Access Compliance Report

Public Rights-of-Way

| Intersection ID: 15398 | Main Street: COLVILLE_RD | Cross Street: HEMPSTEAD_PL | Location: SE |
| ADA ID: 0F2271B1CB1E | Ramp Type: PerpDiag | Initial Pass/Fail: Fail | Overall Compliance: No |

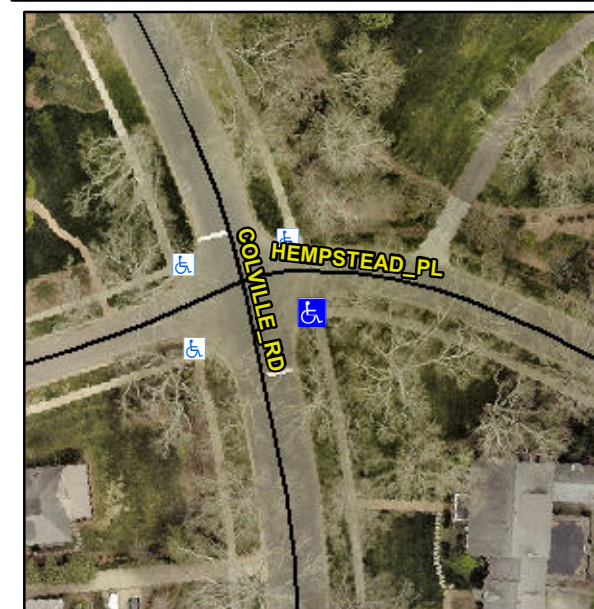
R304.5.3

| Compliance | Description | Data | Compliance | Description | Data |
|------------|-----------------------|------|------------|-----------------------------|------|
| Yes | Ramp Width (in) | 48.0 | No | Ramp XSlope (%) | 2.4 |

Remove & Replace Curb Ramp With Two New Directional Ramps or Equivalent.
